Re: Design of Section 4- Section 5
Louisville Southern –Indiana River Bridges
Pier Load Study

Please find included with this correspondence the revised 12/12/2010 bridge span arrangement as prepared by H.W. Lochner Engineering.

FIGURE 4
REVISED DESIGN OF SECTION 4 KY APPROACH STRUCTURE

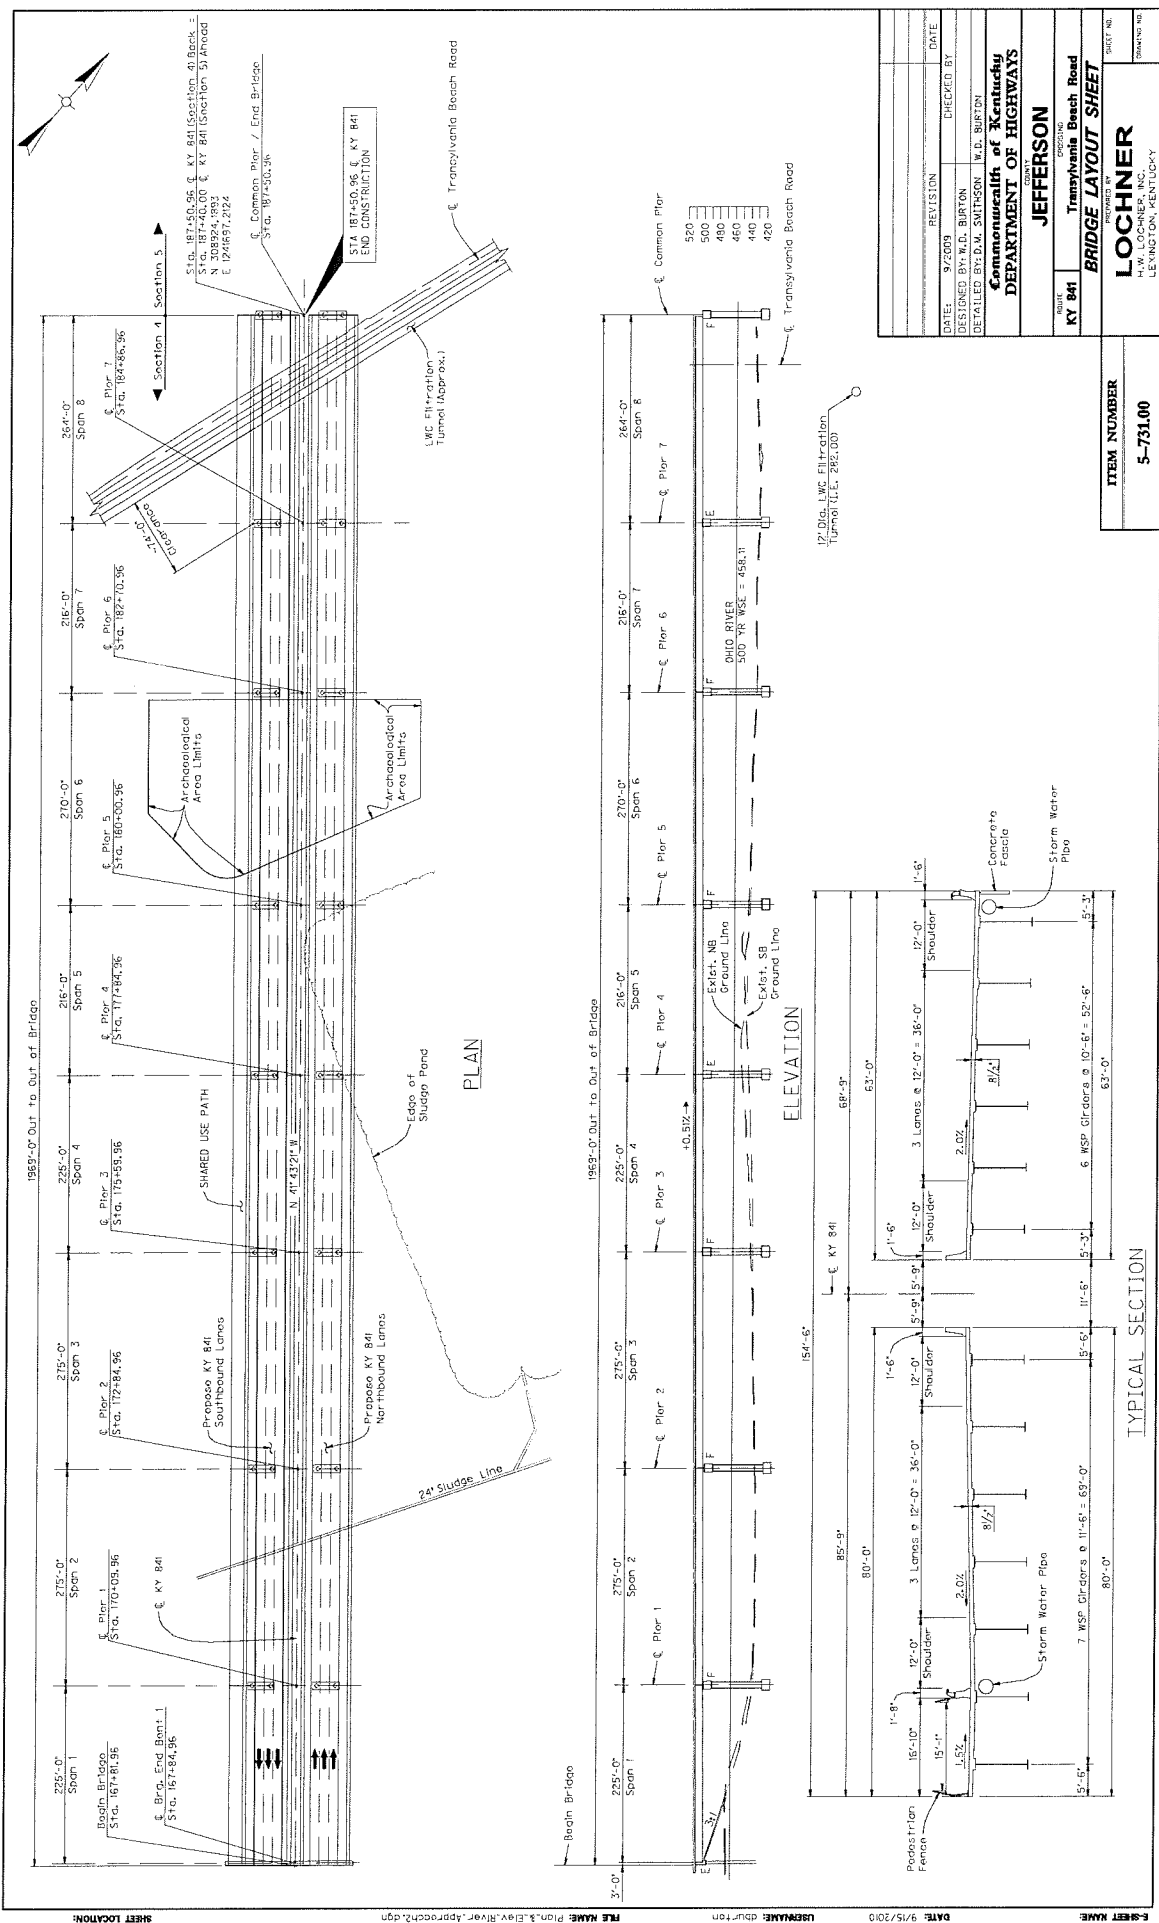
Louisville Water Company (LWC) is in agreement with the proposed alignment in that it meets requirements as specified in the June 2, 2009 letter and May 26, 2009 Technical Memorandum prepared for LWC by Jordan Jones and Goulding, Inc. for the Evaluation of the Impact of Bridge Piers on the RBF Tunnels and the Evaluation of the Impact of the Bridge Piers on Collector Well Screens, hereinafter referred to as the "Technical Memorandum".

In as much as Louisville Water Company concurs with the proposed alignment, this does not negate the Bridge construction practices used in relation to the tunnel and the collector well laterals as stated in the above referenced Technical Memorandum. All construction, subsurface and otherwise, shall be in compliance with the Technical Memorandum and best management practices to protect the groundwater supply within the designated Wellhead Protection Area.
